HPC RESPONSE LETTER

Certificate of Appropriateness
402 W Birch Ave
Flagstaff, AZ 86001
Averbeck ADU

Please see our attached Revision 02 documents for our application for a Certificate of Appropriateness for a new garage/ADU structure at 402 W Birch Ave. The following items have been revised from the Revision 01 documents that were reviewed by the HPC Commission on November 19, 2025.

PROJECT NARRATIVE REV 02

PROPOSED
ROOF PLAN

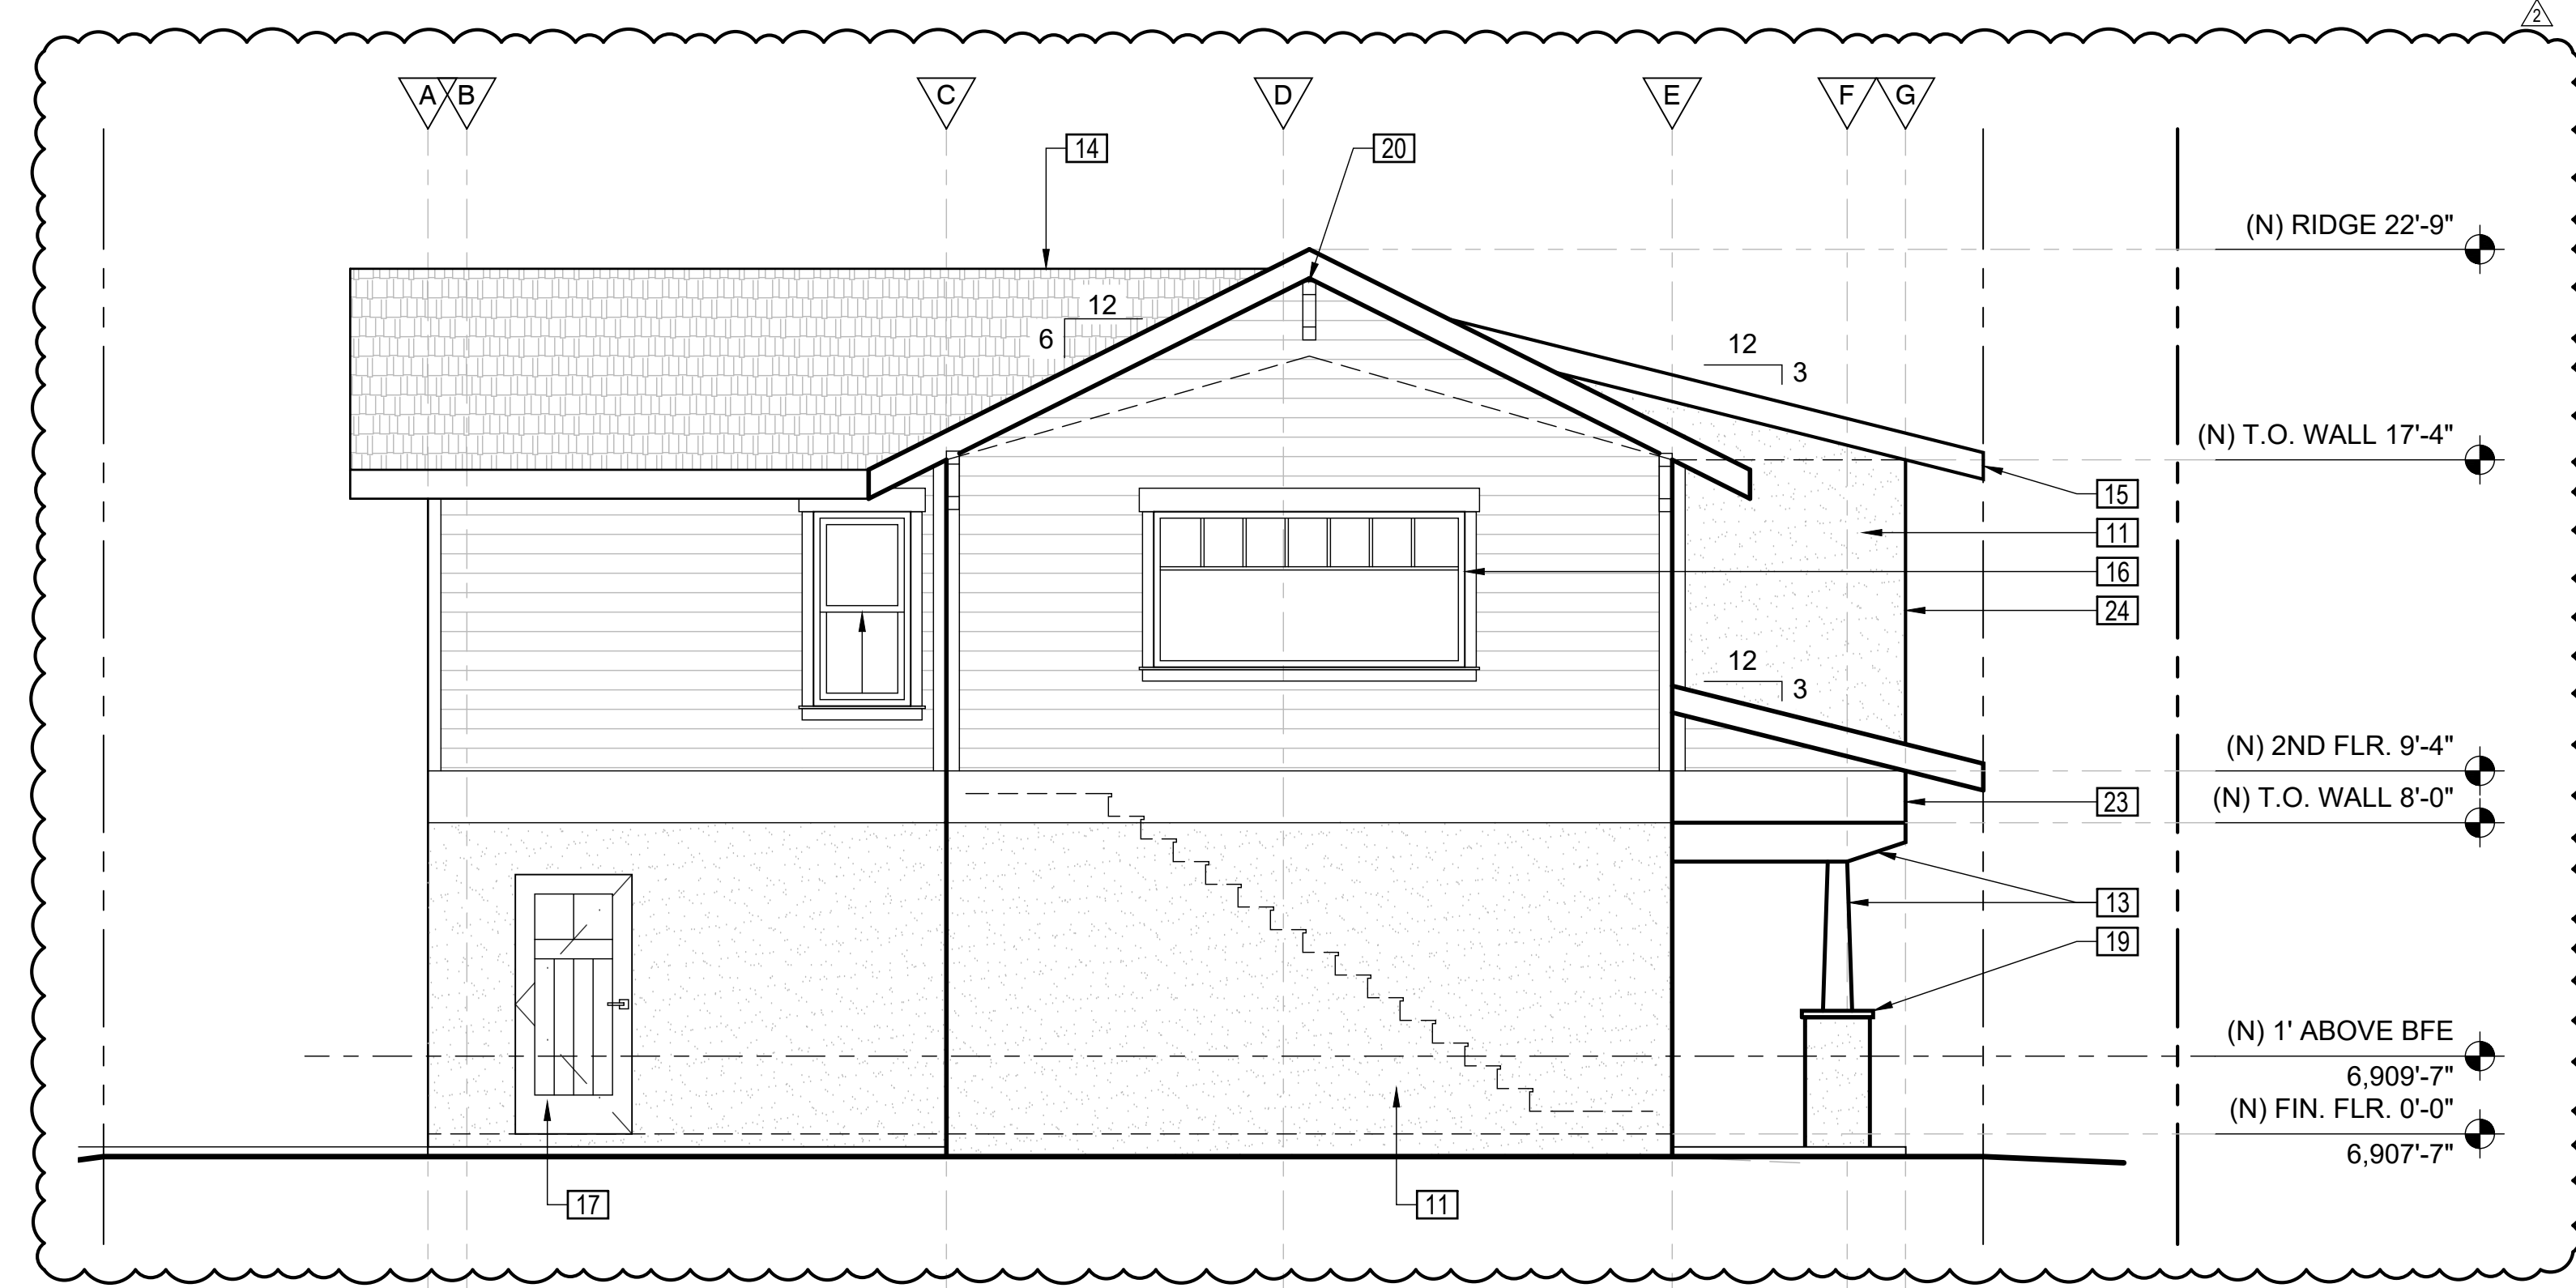
- Lowered the main roof pitch from 8:12 to 6:12, which lowered the overall height by 1'-7".
- The bathroom facing N Sitgreaves was revised to occupy a smaller footprint and have a shed roof to make the mass feel smaller. Windows along this façade were re-designed to create more curb appeal.
- Eliminated the SW raised deck entirely & made the patio below smaller
- Delineated garage door for pedestrian scale and made the single 16'-0" wide door into two 8'-0" wide 7'-0" tall doors.
- The body colors were redesigned with the majority of the darker green on the bottom, with the lighter green on top.
- Changed window frame finish from black to cream to lighten the overall color palette.
